Description of the Site

Analysis of the Cleanup

Enclosure A

Figure 2 – Site Plan with new well actual locations

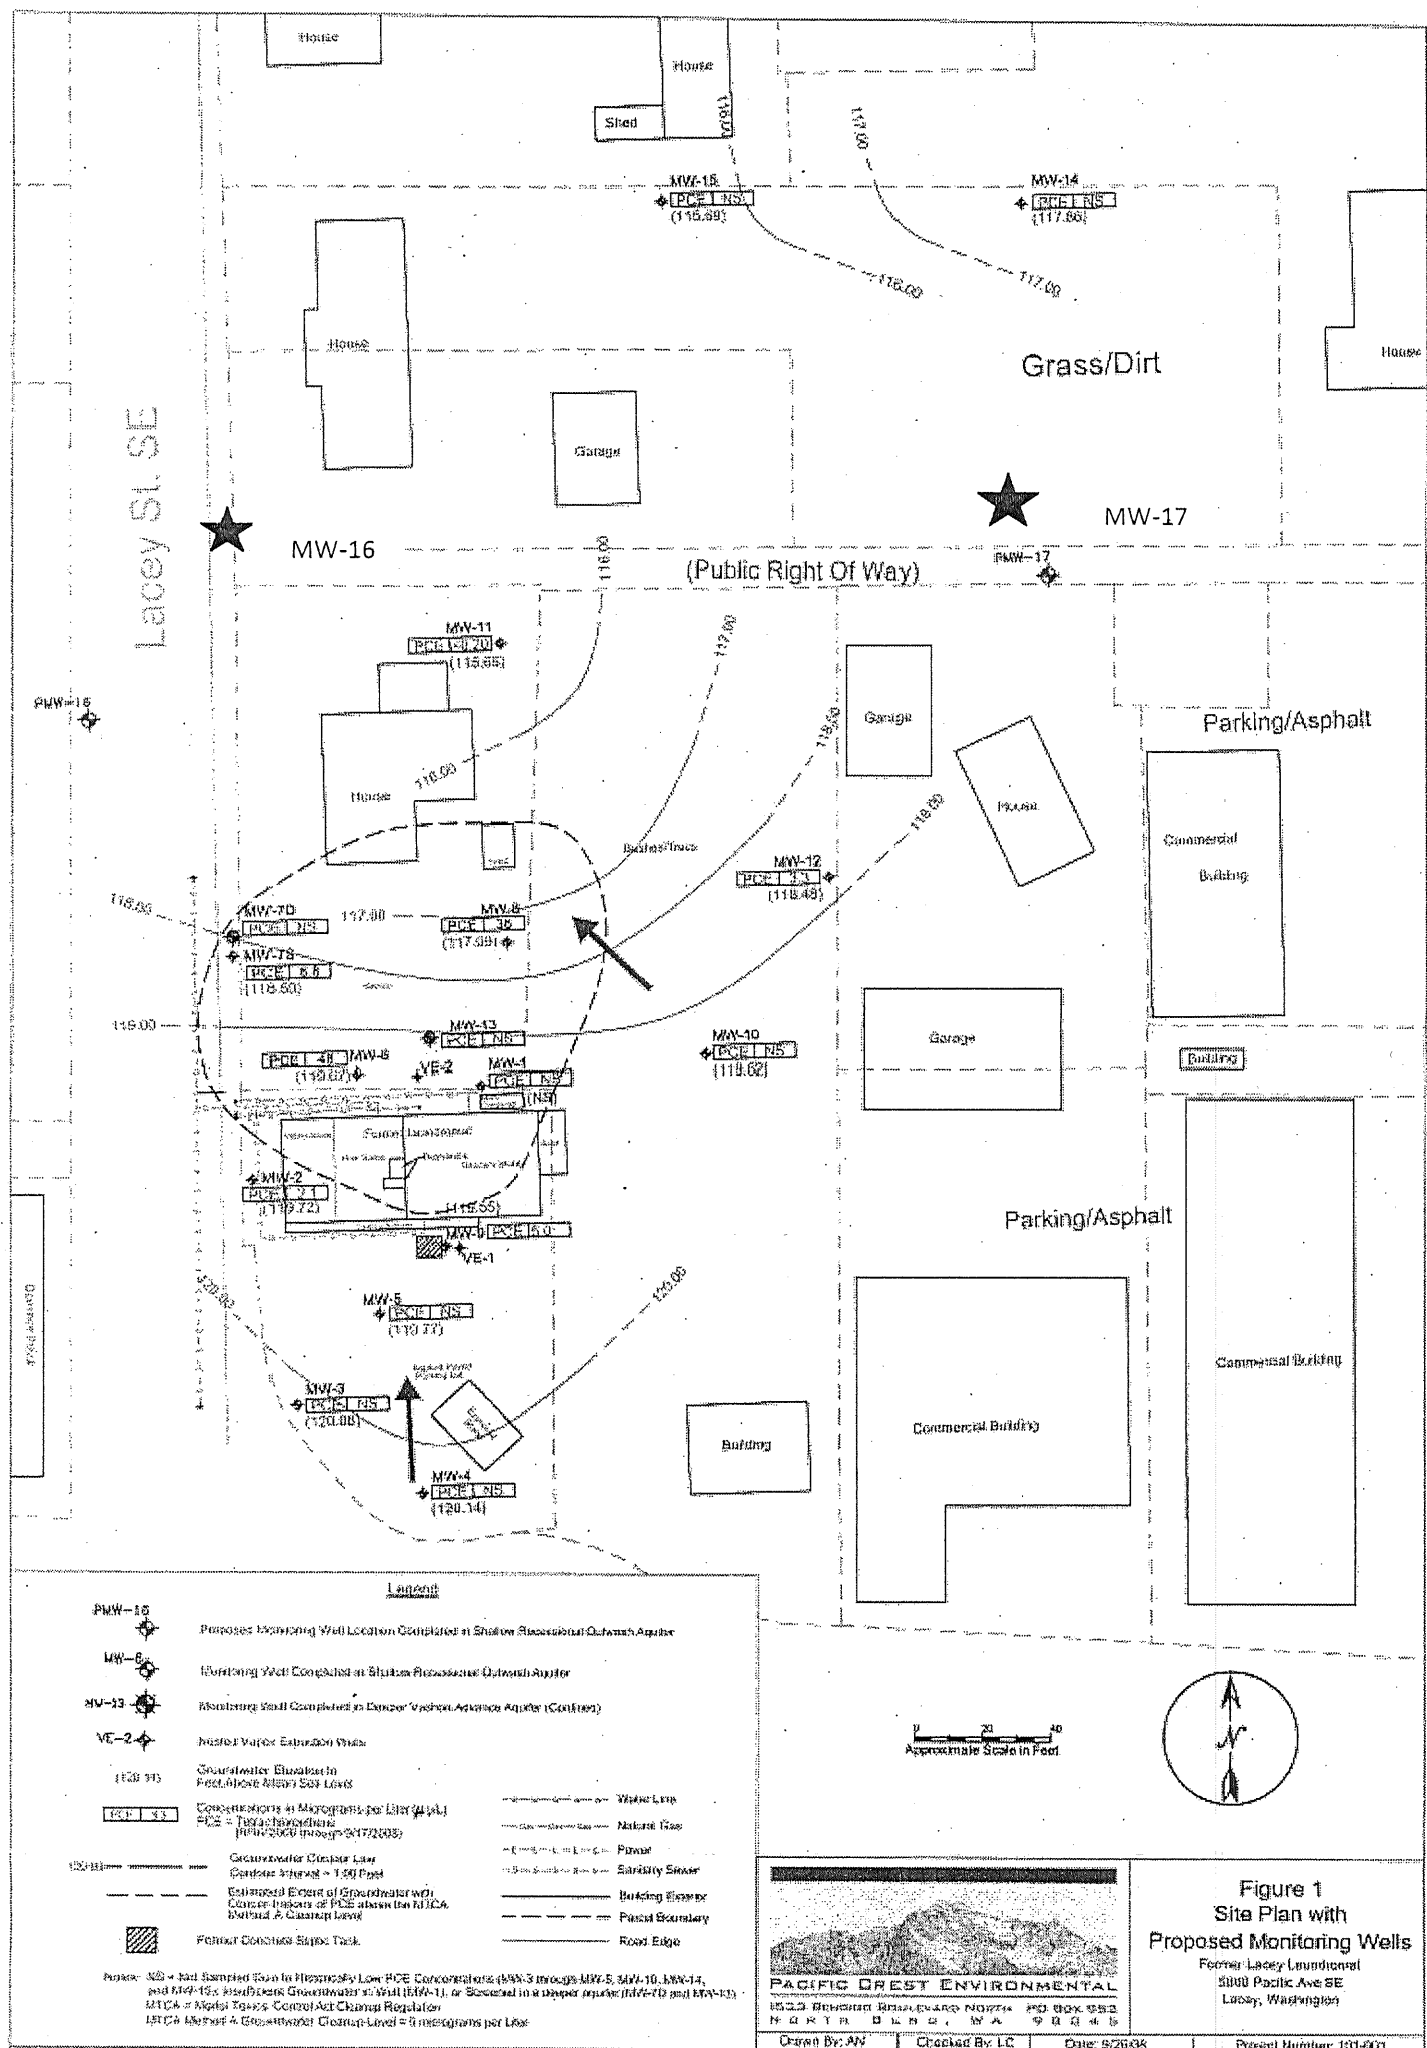
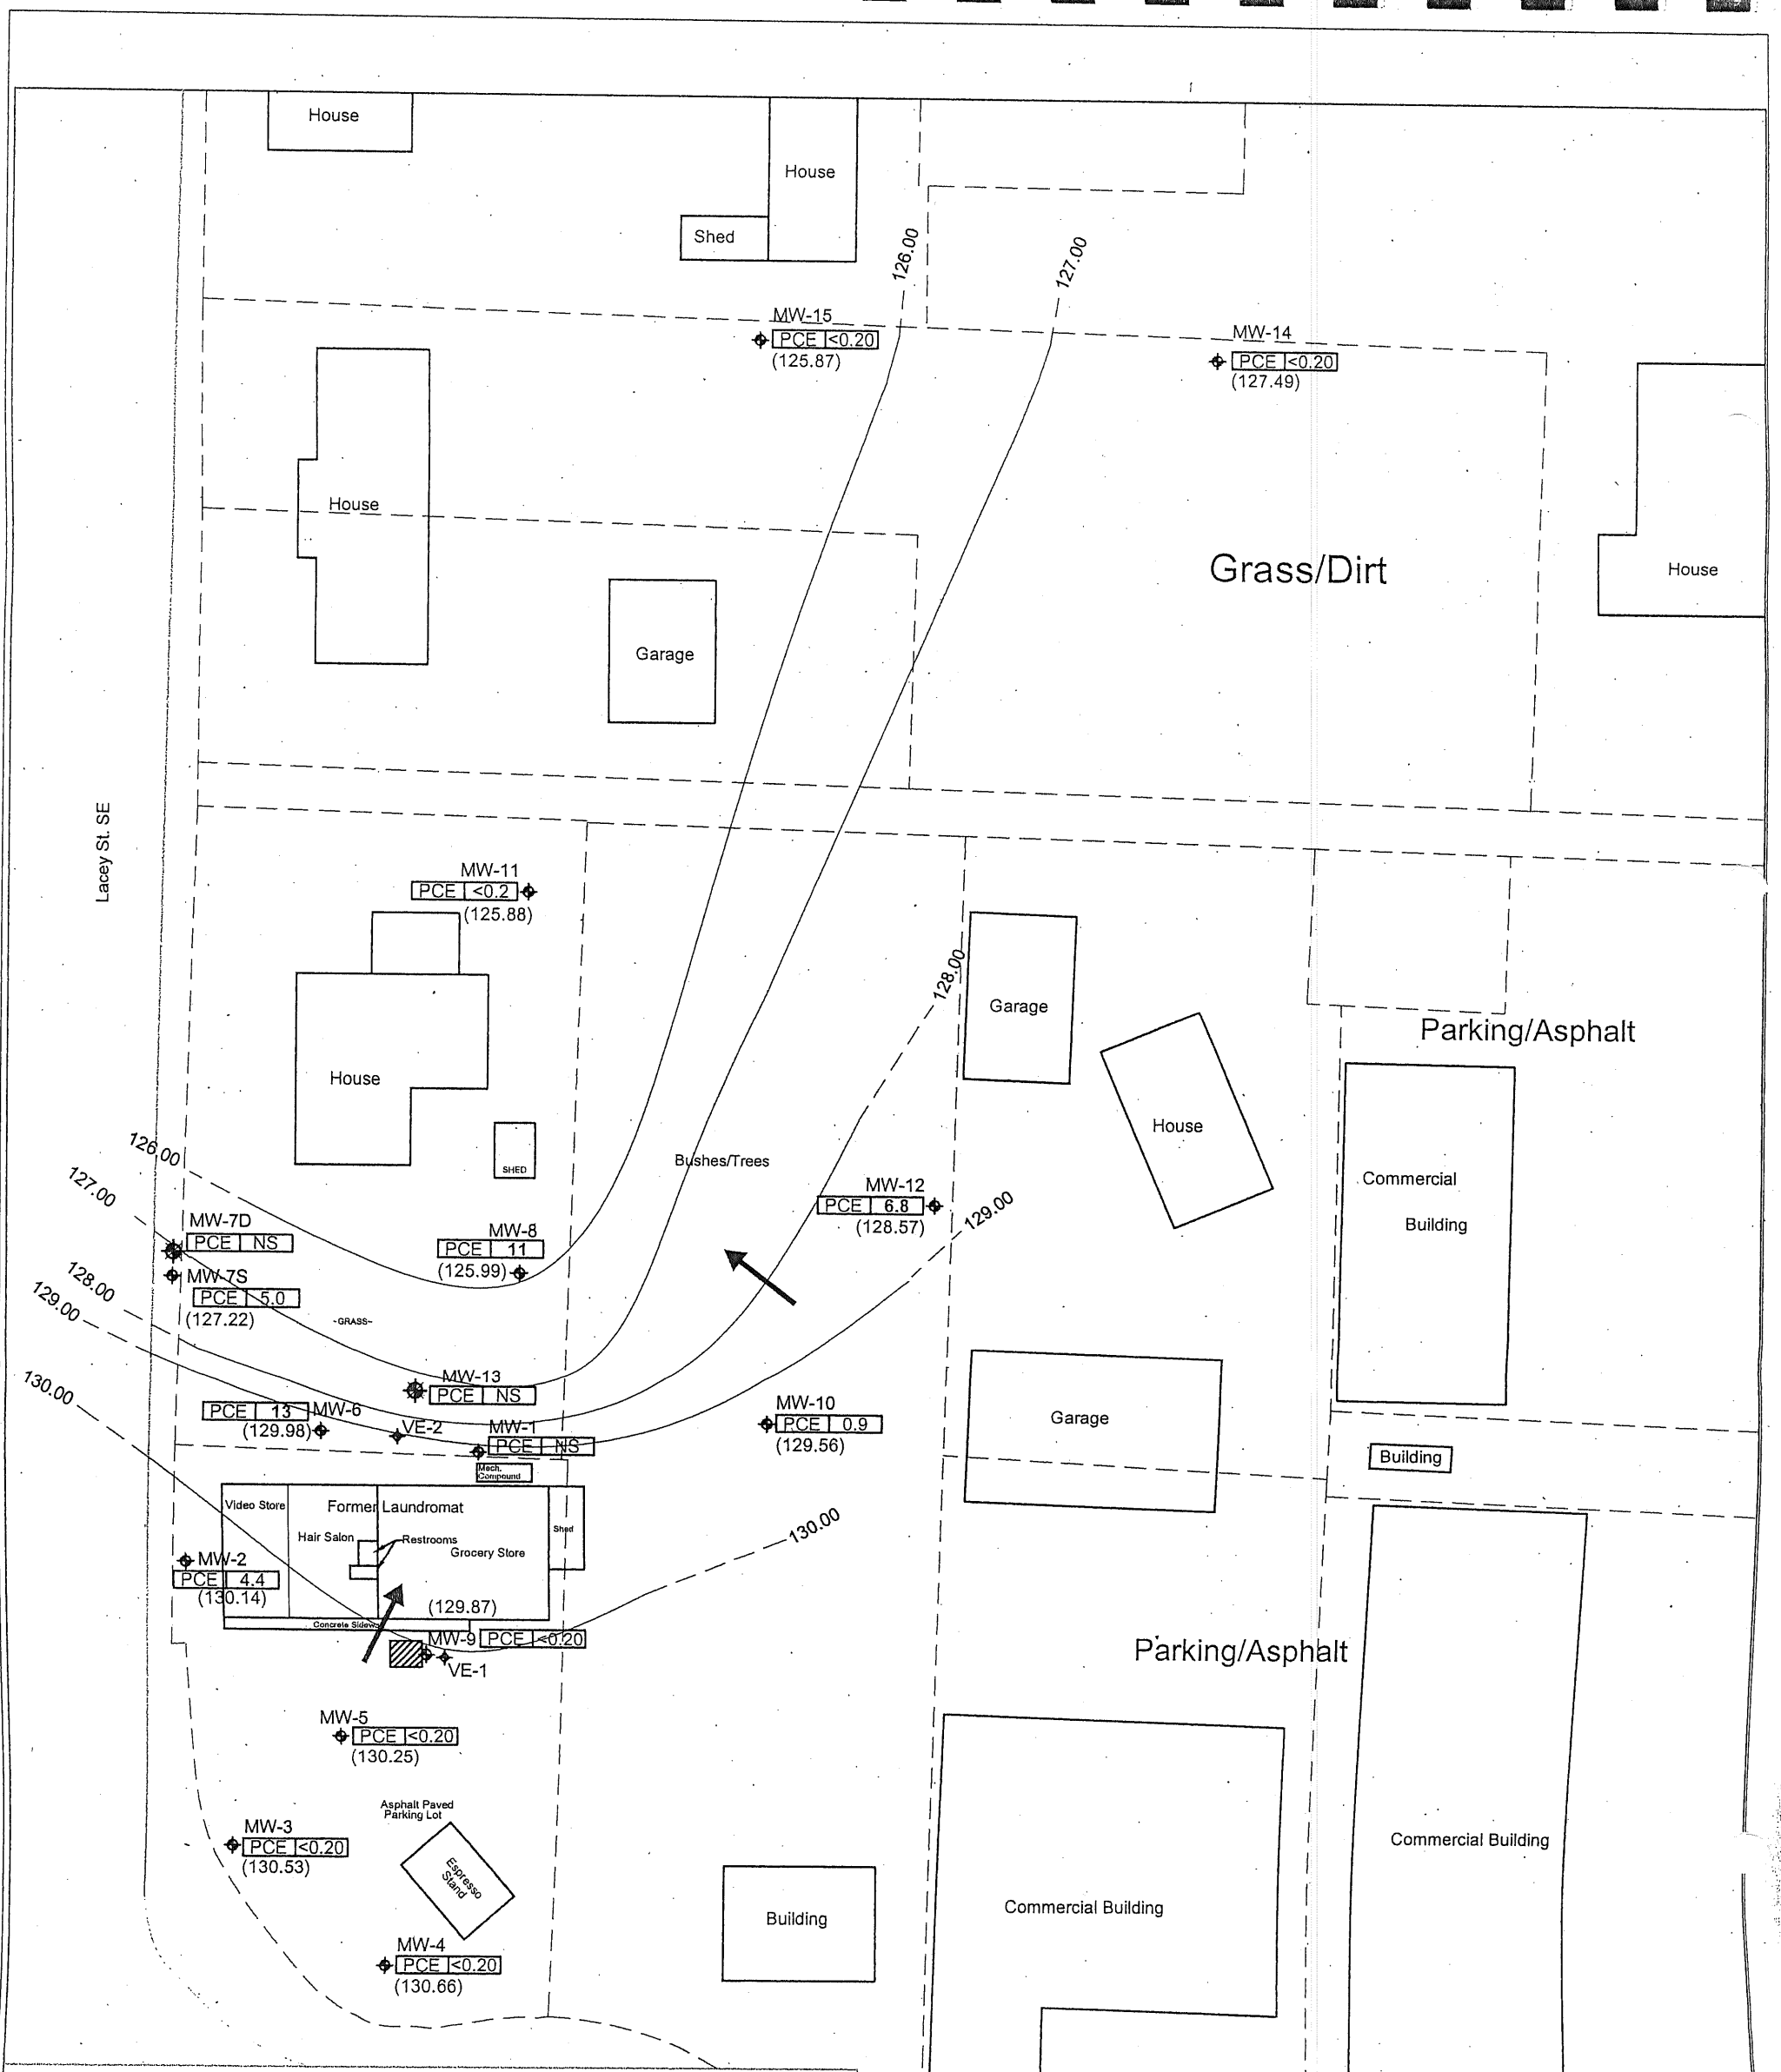
To complete the delineation of the Site boundaries, seven additional ground-water monitoring wells (MW-11 through MW-17) have been installed at the Site since the submittal of the Draft Cleanup Action Plan (CAP). Two of these wells (MW-16 and MW-17) were installed as a result of the last opinion letter, dated August 15, 2008. These wells have been incorporated into the compliance ground-water monitoring program conducted at the Site. Table 1 summarizes the well construction information for the Site monitoring wells. Figure 2 shows the Facility Plan, ground-water monitoring well locations, and extent of ground-water tetrachloroethylene (PCE) plume.

Figure 3
First Quarter 2008
Groundwater Results
 Former Lacey Laundromat
 5800 Pacific Ave SE
 Lacey, Washington

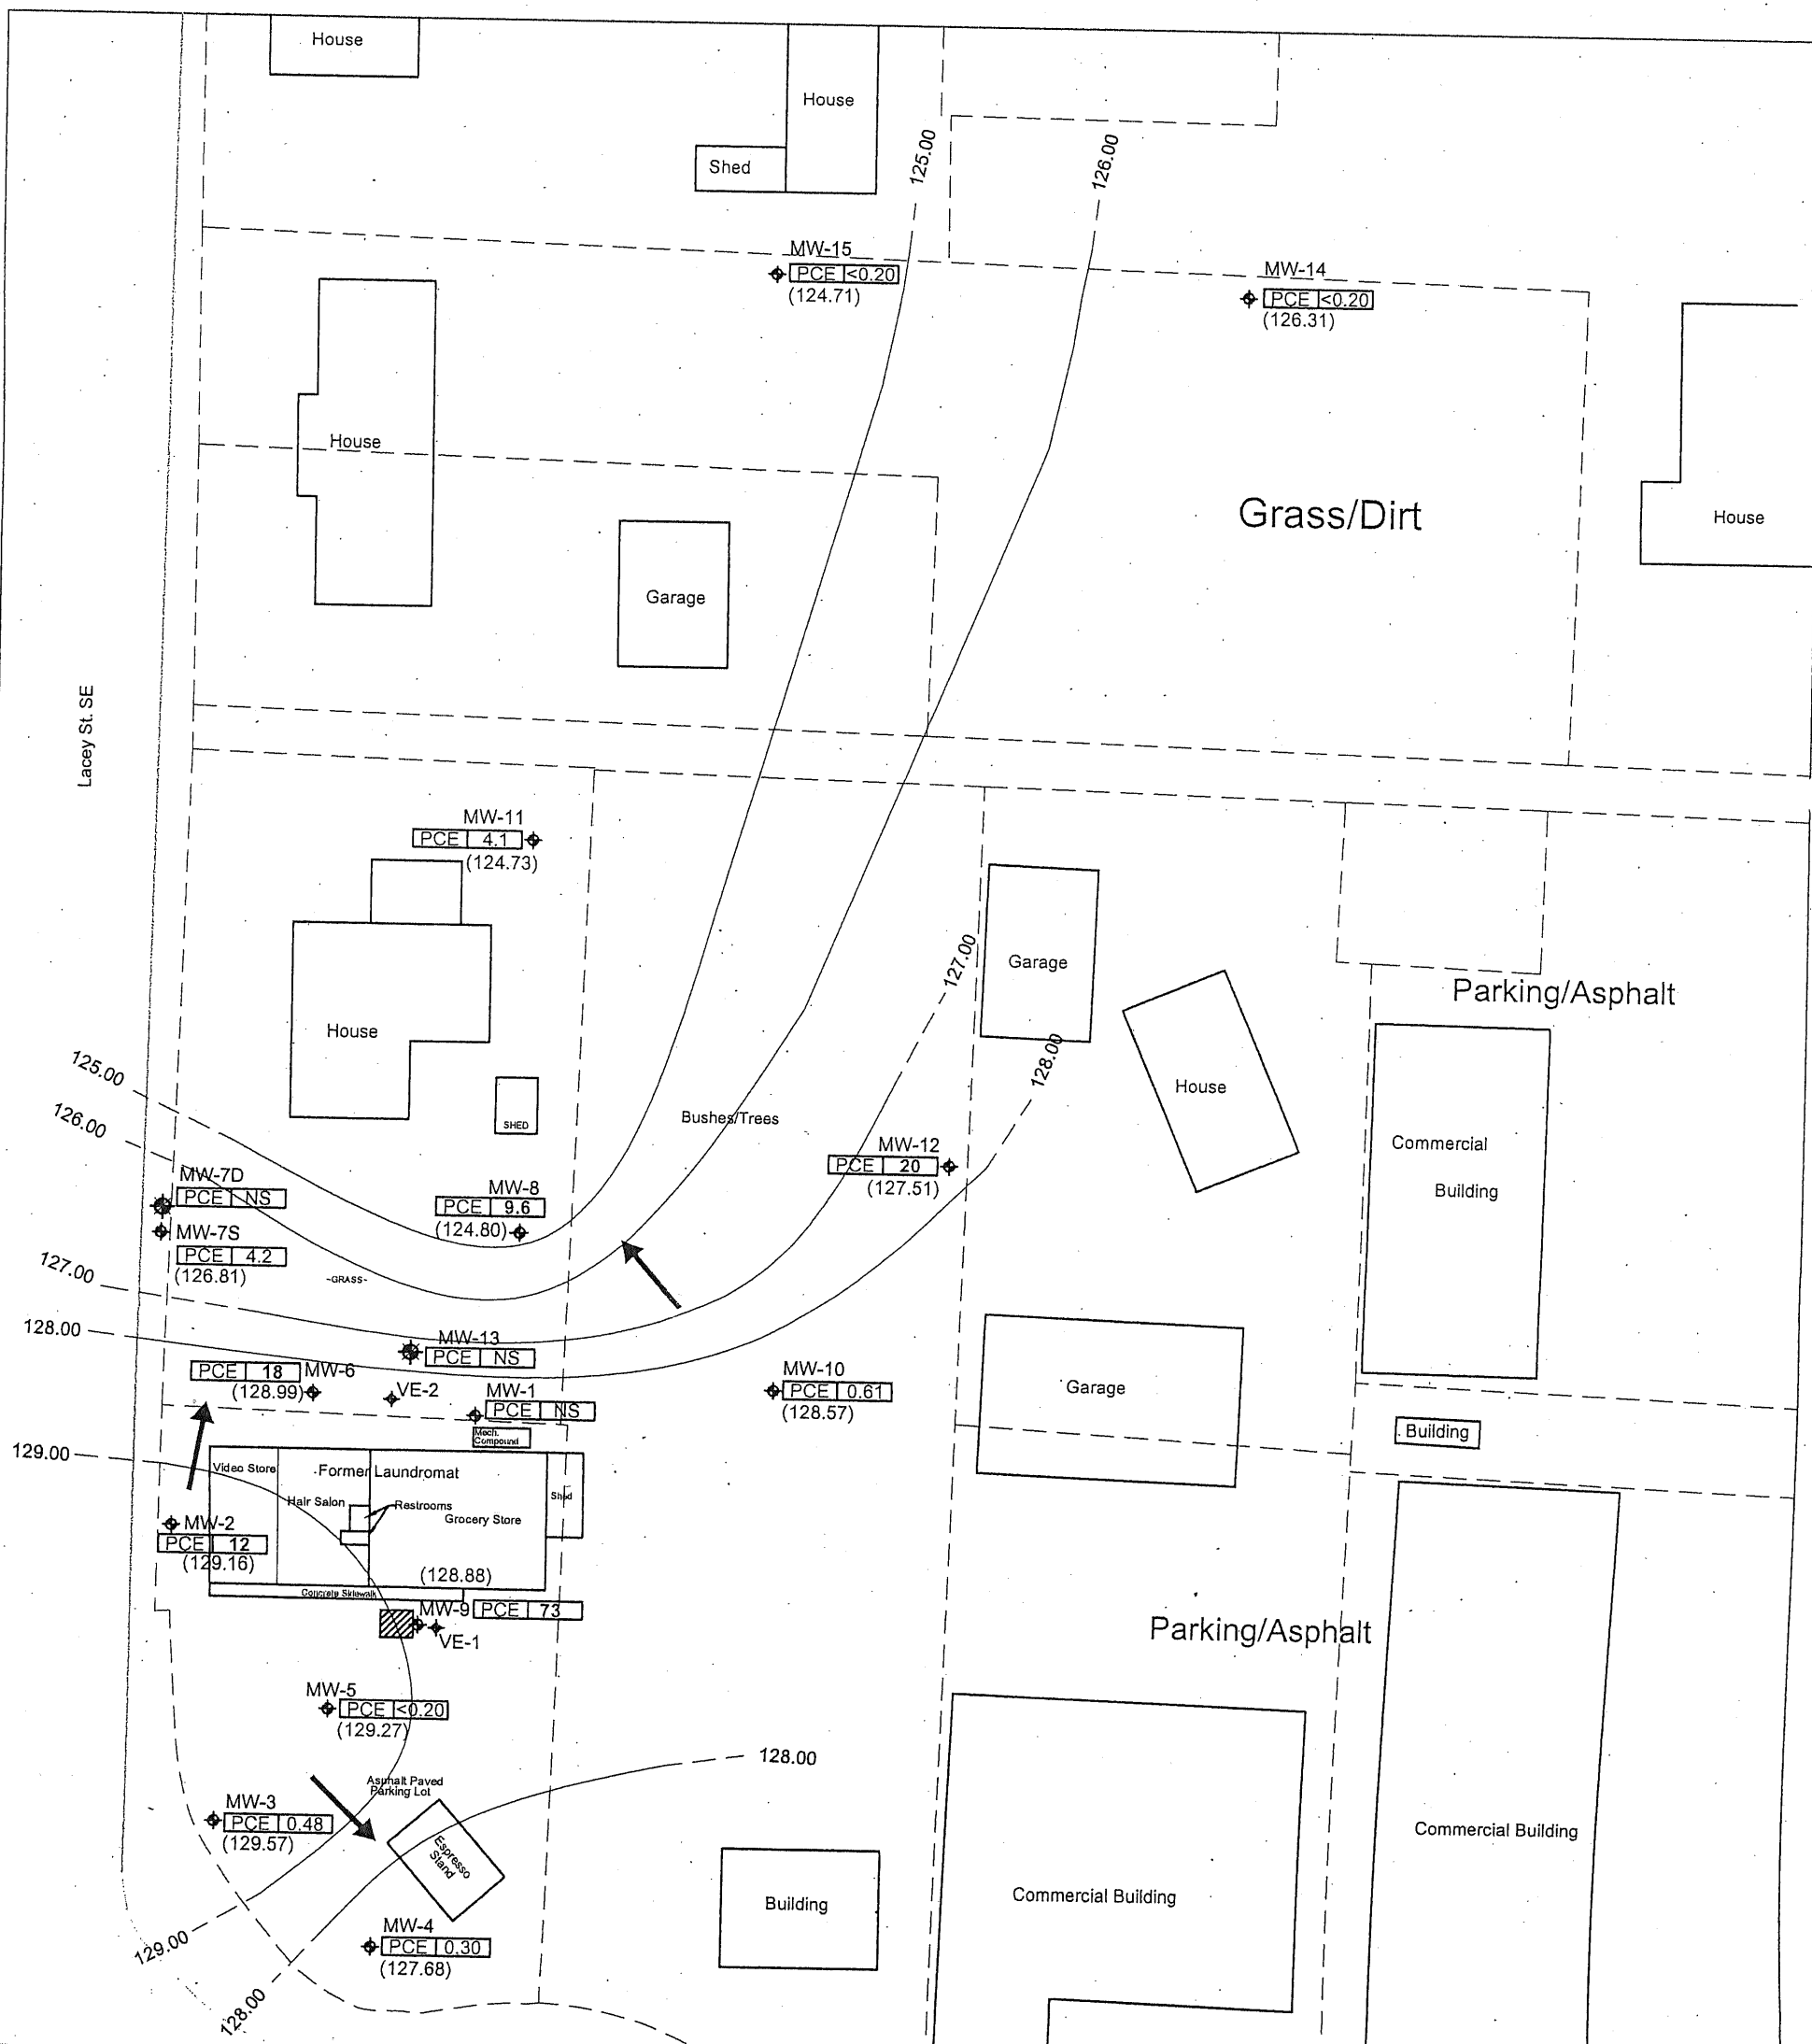
The investigation of source areas at the Site has confirmed that concentrations of PCE in soil exceeding either the MTCA Method A soil cleanup level or the Site-specific Method B soil cleanup level are primarily confined to the near-surface silt-bearing layer that is present from 0 to 5 ft bgs. The additional soil investigation conducted beneath the building does not indicate a substantial previously unidentified source of PCE underlying the building. During the supplemental investigation field activities, a structure inferred to be a concrete septic tank was encountered on the south side of the building. The identification of the inferred septic tank, and the elevated concentration of PCE in ground water adjacent to the concrete tank in well MW-9, suggests that this location is a source of PCE contamination at the Site (Figure 3).
